Re: Florida Power & Light Company  
Proposed Turkey Point Units 6 and 7  
Docket Nos. 52-040 and 52-041  
Response to NRC Request for Additional Information Letter No. 61 (eRAI 6432)  
Related to SRP Section 03.07.01 - Seismic Design Parameters

**FPL Response to NRC RAI No. 03.07.01-15**

**SRP Section: 03.07.01 – Seismic Design Parameters**

**NRC RAI Number: 03.07.01-15 (eRAI 6432)**

**Figure 2.1-3**  
**NI H1 Horizontal Within ARS at TPNP Foundation El. -16'**

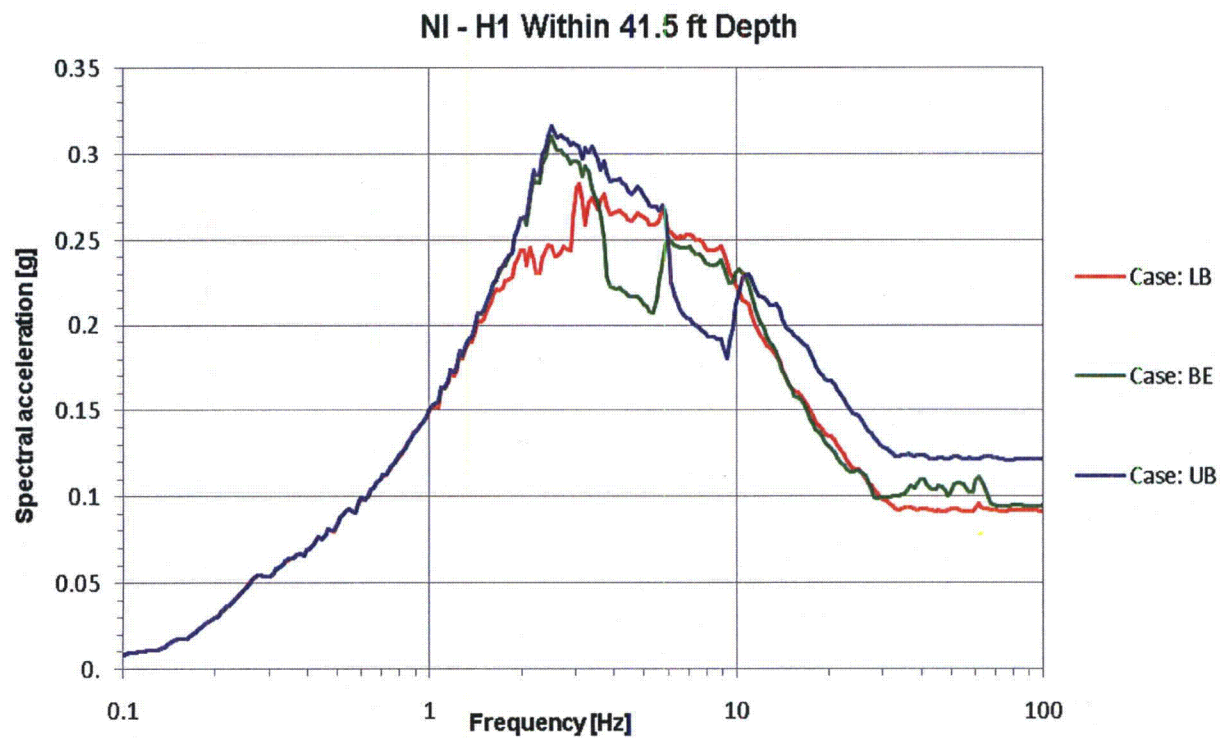
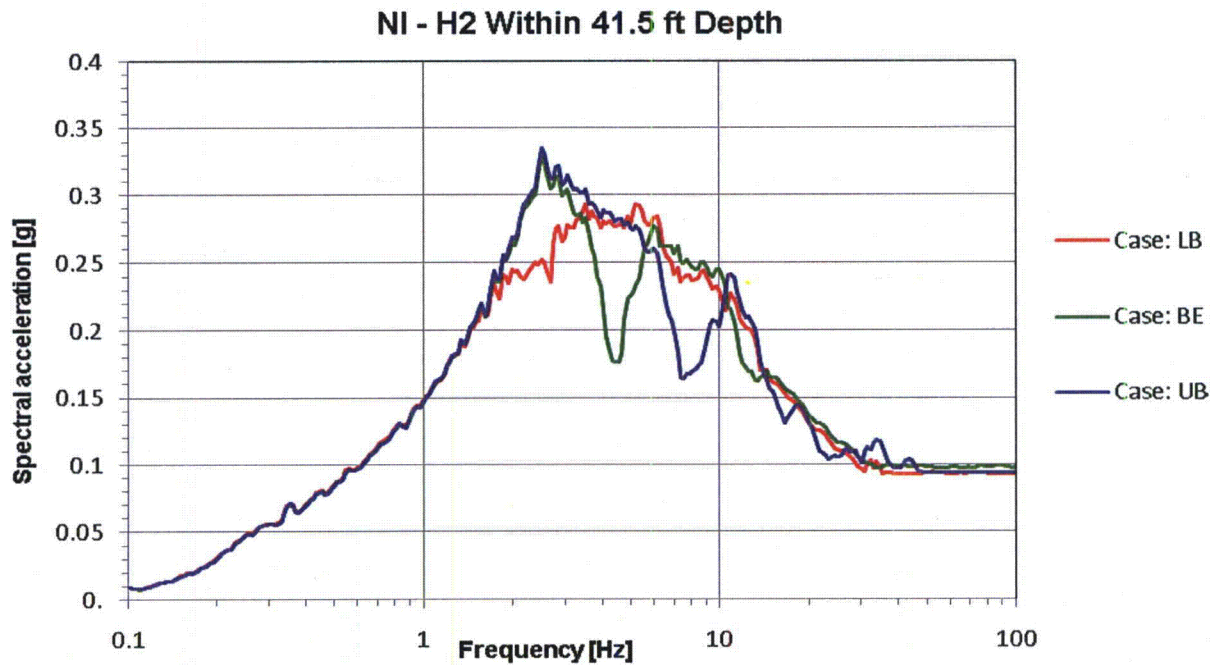
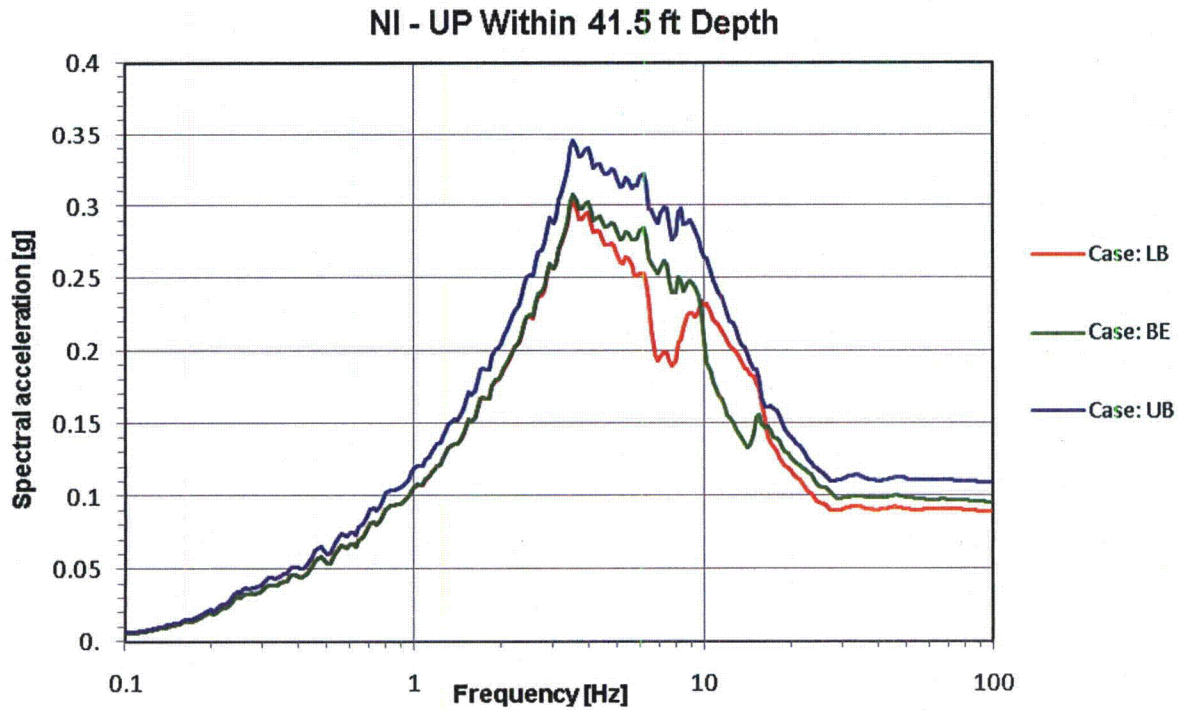
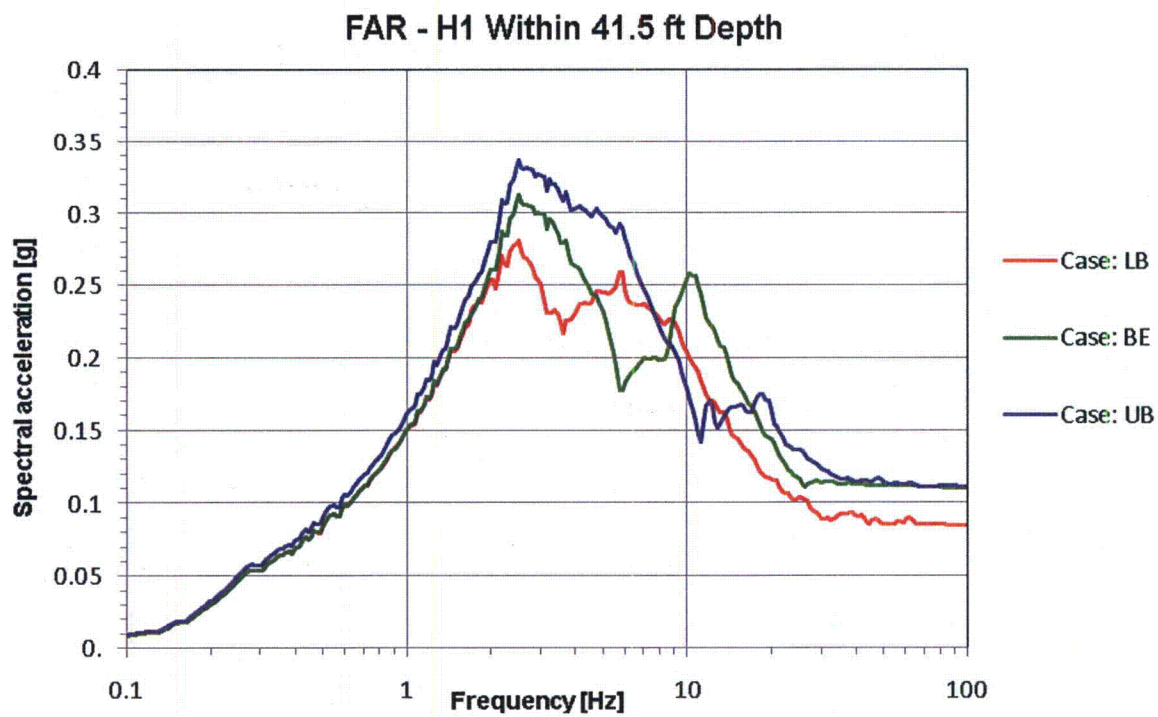
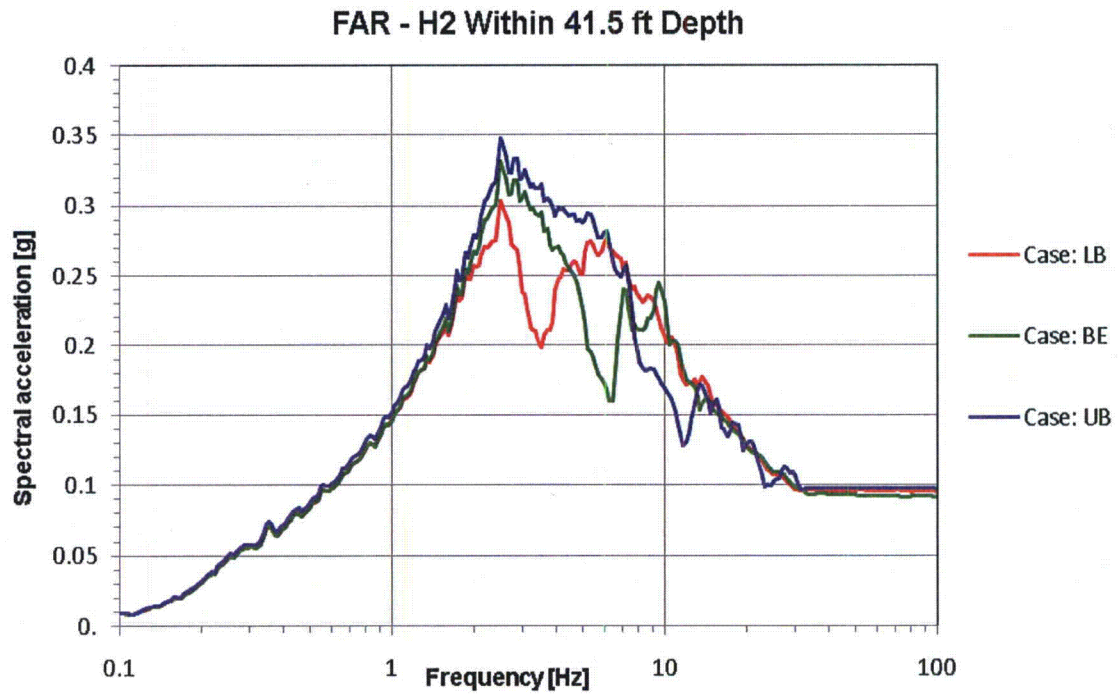
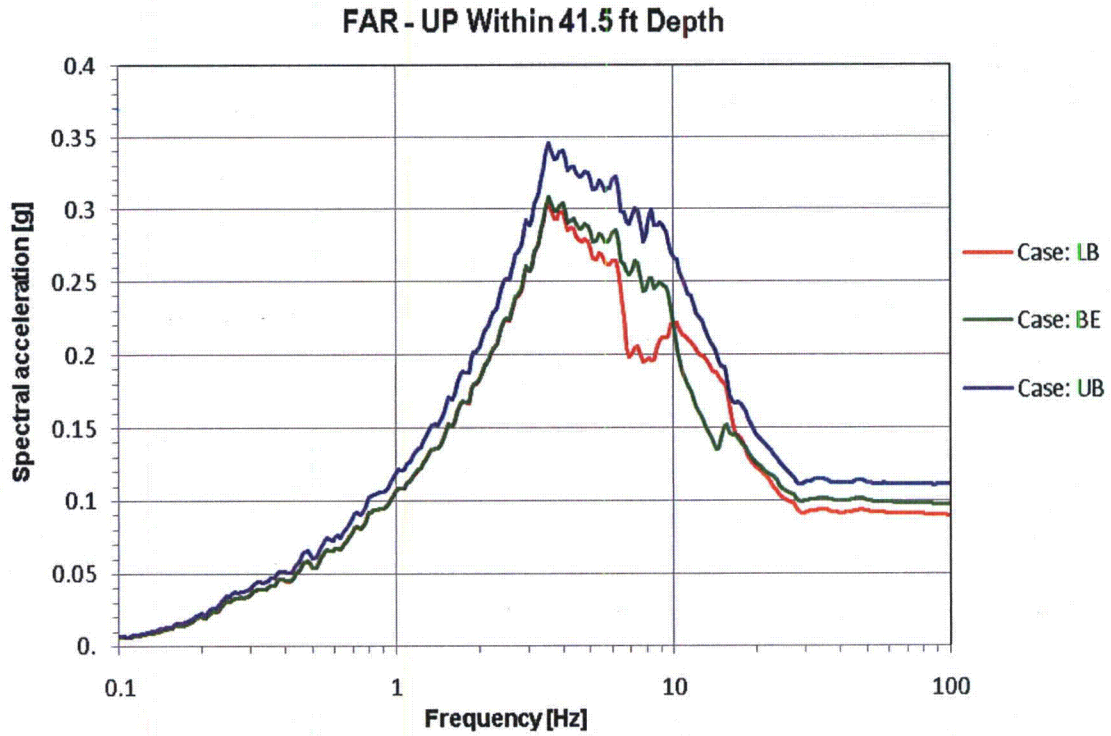
In Revision 3 of the applicant's FSAR, (aka. TPG-1000-S2R-802, "Turkey Point Site-Specific Seismic Evaluation Report") Figures 2.1-3 through 8 show the response spectra at the foundation level. These spectra have zpa values that are less than the 0.1g at the foundation depth that is required by Appendix S to 10 CFR Part 50. (Note that this issue was previously identified in a question on Figure 2.5.2-252 regarding the input motion at Elevation -35). The response spectra shown in those figures form the basis of the input motions that are used to compute the in-structure response spectra (ISRS) from the SSI analyses. Meeting the Appendix S requirements would appear to require adjusting the input motions upward which would result in margins, as compared to the DCD ISRS at the six key locations, to reduce significantly from those indicated in the tables mentioned above. Additionally, it is noted in the AP1000 DCD that the CSDRS is at finished grade. Since the input motion at the foundation level is less than the minimum required by Appendix S, the surface spectra shown in Appendix 3JJ, which neglect any adjustment required to satisfy Appendix S, appear to be understated. Thus, the applicant is requested to provide a discussion as to how the results provided in Appendix 3JJ and Figures 2.1-3 through 8 meet the Appendix S to 10 CFR Part 50 requirements for minimum seismic input at the foundation level.

In Revision 5 of TPG-1000-S2R-802, "Turkey Point Site-Specific Seismic Evaluation Report", Section 2.1 presents a summary of the Turkey Point Units 6 & 7 free-field site response analyses, which updates the information from the Revision 3 report and presents detailed descriptions of how the Appendix S to 10 CFR Part 50 requirements for minimum seismic input at the foundation level are met.

The horizontal and vertical BE, LB and UB “within” ARS at the Turkey Point foundation El. -16 ft are shown in TPG-1000-S2R-802 Rev. 5, Figures 2.1-3 through 2.1-5 for the NI (near) site conditions, and Figures 2.1-6 through 2.1-8 for the FAR site conditions. Figures 2.1-9 through 2.1-14 also present the comparison of the computed surface motions to the respective DRS for each directional component (H1, H2, V), each soil case (BE, LB and UB) and each site condition (NI and FAR) using the site-specific FRS.
